Appendix A - To supplement the Wiltshire Council's Landscape Officers (interim) consultation response for **PL/2023/03359** – New anaerobic digestion facility - Land West of Ashton Road, Ashton Keynes, Wiltshire, SN6 6QT.

This document comprises a review of the Landscape and Visual Impact Assessment (LVIA) submitted to accompany a planning application for a development proposal which seeks full planning consent for the construction, operation and decommissioning of a new anaerobic digestion facility, ancillary infrastructure and construction of new access from Ashton Road at a site located on land West of Ashton Road, Ashton Keynes, Wiltshire, SN6 6QT.

This LVIA review has been carried out by Mark Goodwin CMLI, Senior Landscape Officer, Wiltshire Council. It follows on from a number of previous landscape consultation responses already provided for this application.

6. Additional Viewpoint – Views from Cotswold Community – Residents, public users of open space (ES Addendum-Rev 03, Appendix C, represented by Viewpoint 10).

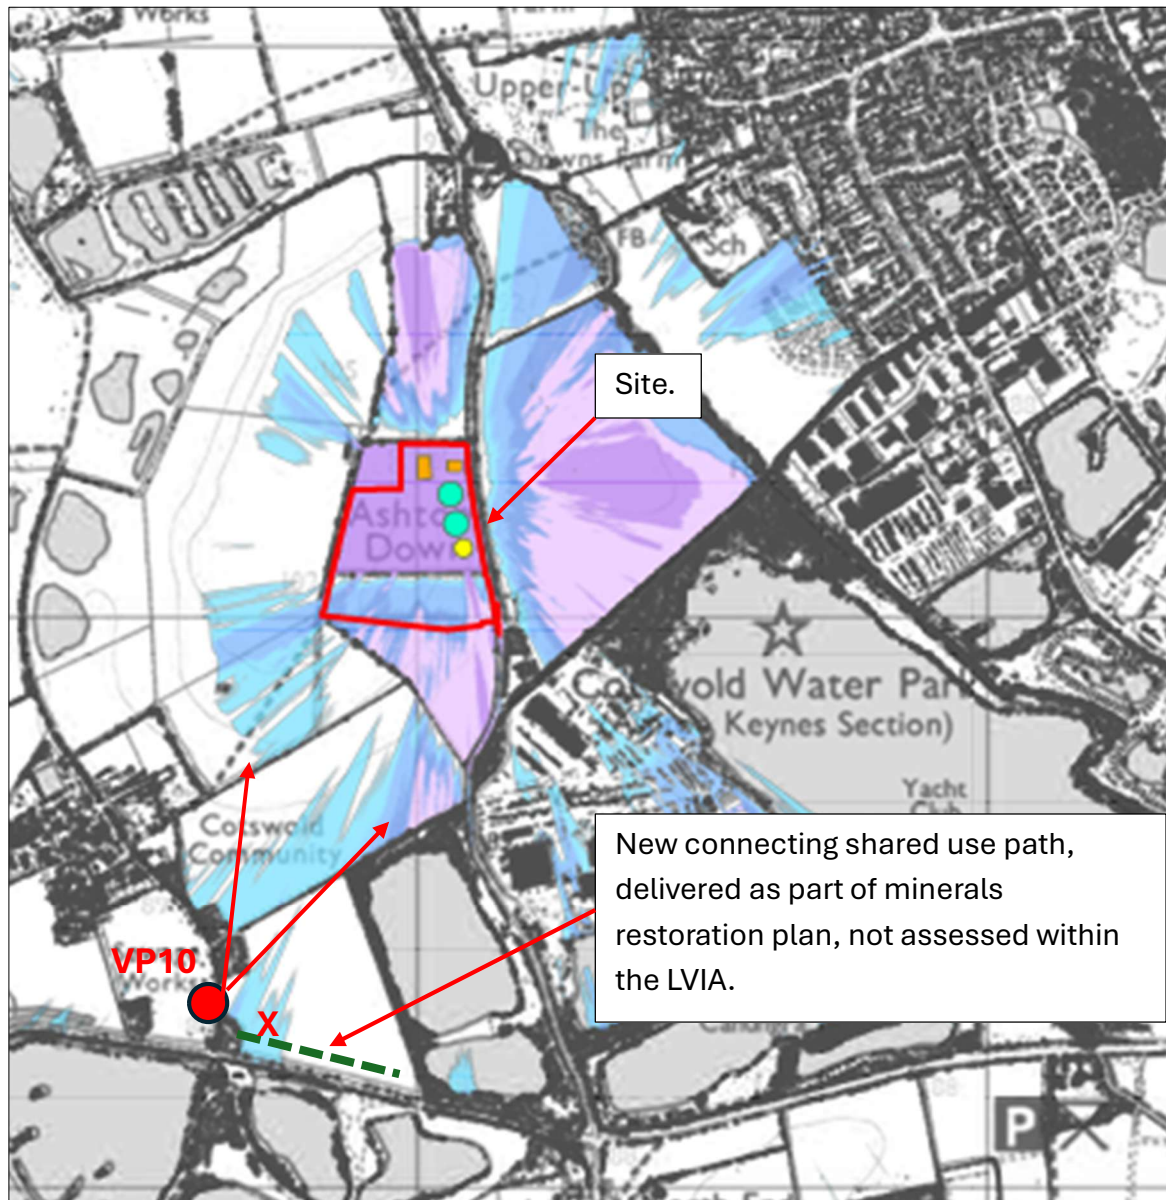
A request was made during a site meeting with the applicants appointed landscape consultant for an additional viewpoint/s to be included from public open space within the new housing development at the Cotswold Community and from the new footpath linking east from the Cotswold Community running inside the roadside hedge with Spine Road West. The viewpoint 10 photography illustrates that the development is unlikely to be visible from within the Cotswold Community for users of new public open spaces within development, although private residential receptors from upper rooms in the eastern edge of the Cotswold Community are likely to view the top of the 16.5m high digester tank.

Requested views from the new public route close to the Cotswold community, where the Screened Zone of Theoretical Visibility Map indicates that there is potential for some shared

intervisibility from this receptor, with upper parts of taller development components. This receptor remains to be assessed (see extract below).

It is likely that the upper level of the taller 16.5m high digester tank will be visible to view from a short length along this public route at its western end, denoted with an 'X', especially during winter months. Viewpoint 10 is located slightly further west and further into the site viewed from a private access road within the Cotswold Community Development. However, I do not anticipate the visual effects would represent a Major Adverse significant effect for users of this route.
